# **WSX-C20 – Cost adjustment claims**

Response to  
Ofwat's PR24 draft  
determination

## Representation reference: WSX-C20

### Representation title: Cost adjustment claims

Figure 1 – Reproduction of Figure 4 from Ofwat’s Mains CAC Assessment

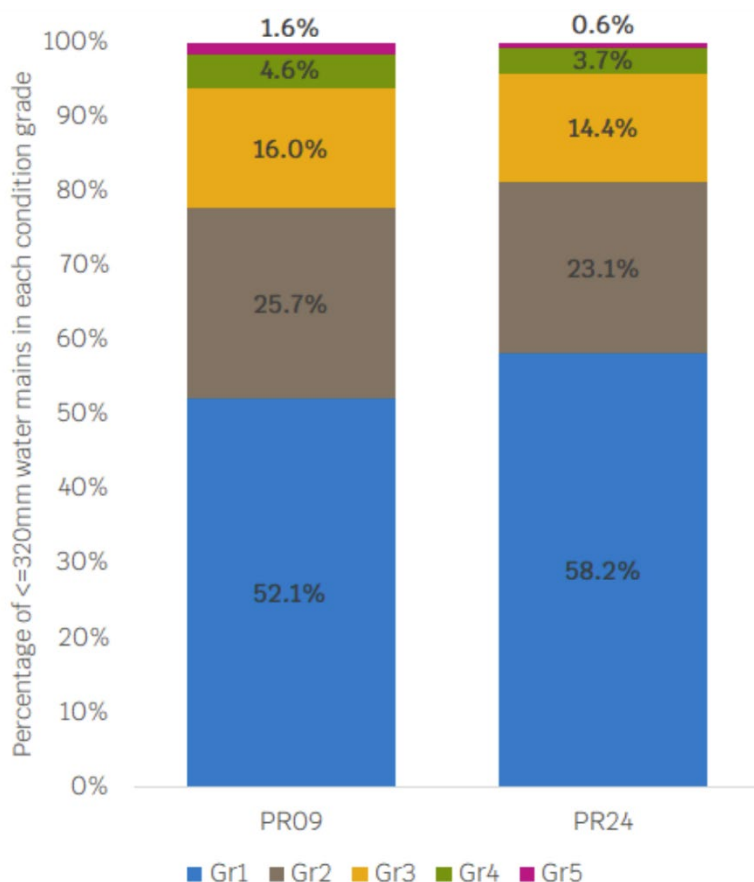
Ofwat’s analysis, using the network quality data, shows that the industry as a whole had 51.2% Grade 1 pipes at PR09, relative to 58.2% at PR24. This represents a 6.1pp increase.

Simultaneously, Ofwat sets out (using the mains replacement timeseries) that companies have been replacing mains at a rate of 0.32% per year out of total expenditure. In the 15 years since PR09, this suggests that (assuming no decline in network quality whatsoever) that companies should have increased their proportion of Grade 1 pipes from 52.1% to 56.9%<sup>11</sup>, which is 1.3pp less than they appear to have replaced, based on the network quality data. This discrepancy would be even larger if (as would be expected) a proportion of those replaced mains would have declined in quality (e.g. to Grade 2) in that 15 years.

Ofwat uses the network quality data to conclude that, on the basis that 4.3% of industry mains are Grade 4 or 5 at PR24 (seen in Figure 1), “[a]ssuming no further deterioration, the sector needs to replace mains at a rate of 0.43% per year on average to replace all grade 4 and 5 mains over the next ten years...we consider this a reasonable expectation”<sup>13</sup>.

Figure 2 – The apparent deterioration in our network quality is inconsistent with the mains replacement timeseries

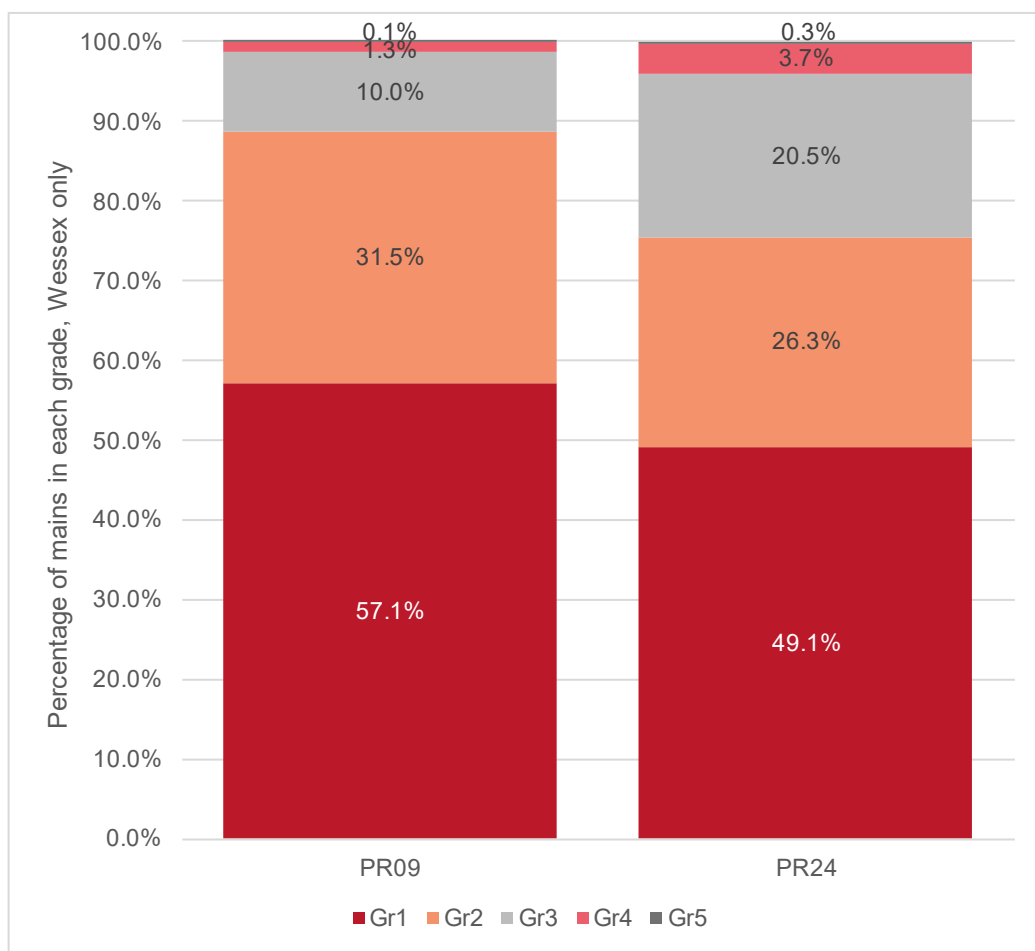
For our network, the equivalent discrepancy is substantial. The mains replacement timeseries shows that we have been replacing mains at an average rate of 0.42% per year out of total expenditure. In the 15 years since PR09, this suggests that (again, assuming no decline in network quality) we should have increased our proportion of Grade 1 pipes from 57.1% to 63.4%<sup>12</sup>, which is 14.3pp more than we see in the network quality data.

We consider that it is plausible that this discrepancy occurs in the data because mains quality has been reallocated over time, or other engineering logic.

Figure 3 – Wessex has performed consistently above the industry average in mains replacement

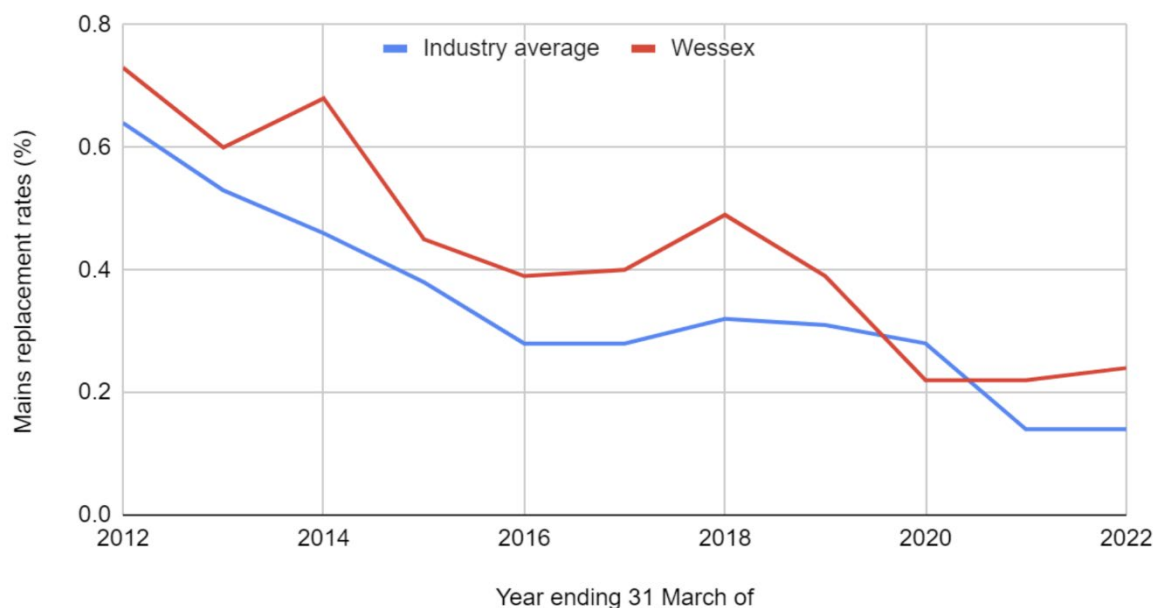
- **We have already been replacing mains at a rate higher than the industry average (through base expenditure).** As previously discussed, we have been replacing mains at an average rate of 0.38% per year through base expenditure, which is higher than the industry average of 0.30%. We have performed consistently above the industry average over the last 11 years<sup>16</sup>.

On this basis, us receiving additional funding to finance mains replacement is not at odds with “[p]reventing customers paying twice for water mains replacement” as the level of service provided by Wessex is already greater than base cost allow for (i.e. what Ofwat has determined that “base buys”).

Figure 4 – Wessex was an industry leader in mains quality at PR09

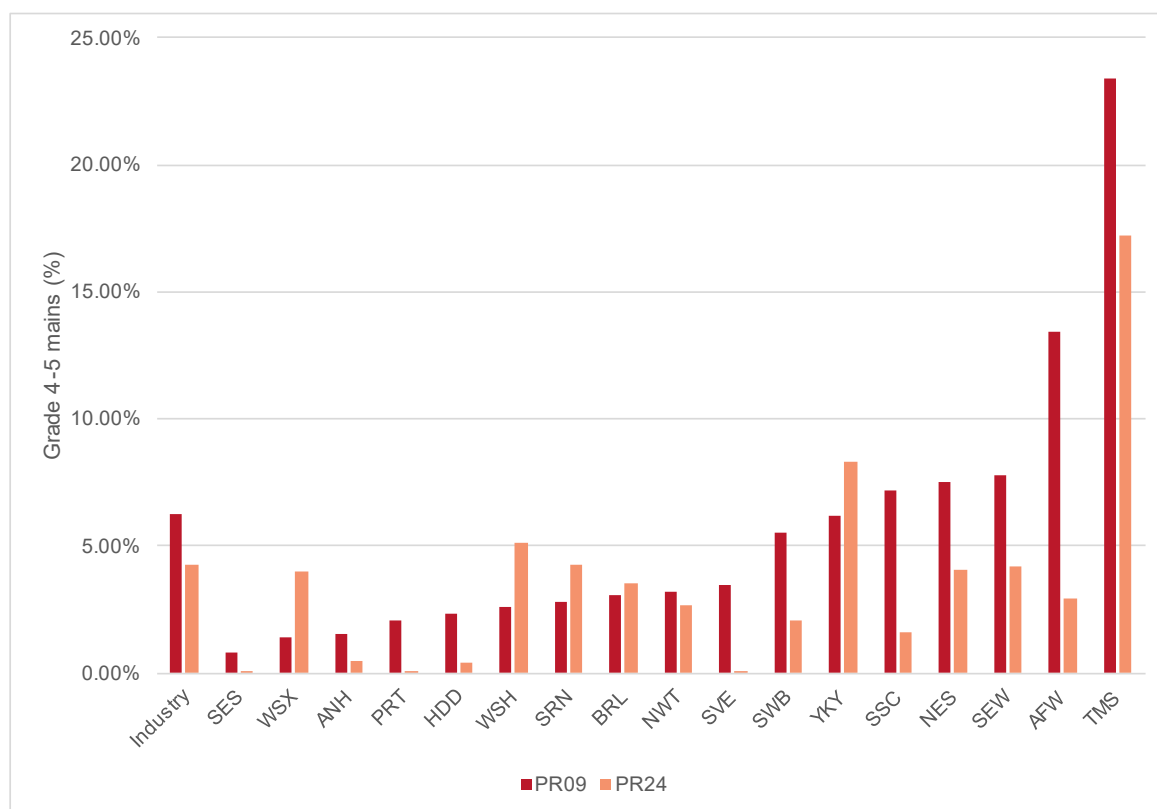
Figure 4 also reveals a further inconsistency of Ofwat’s challenge on mains replacement. We note that Ofwat has proposed to grant Yorkshire Water and Southern Water additional funding to meet the higher minimum mains replacement rate, since they have a growth in Grade 4-5 mains below the 2.2% threshold. However, it can be seen that Wessex has maintained a better network quality (fewer Grade 4-5 pipes) than both companies at PR09 and PR24. We consider that our actual network quality at PR09 and PR24, not just our change in network quality, should be factored in to Ofwat’s decision to apply additional stretch to Wessex.
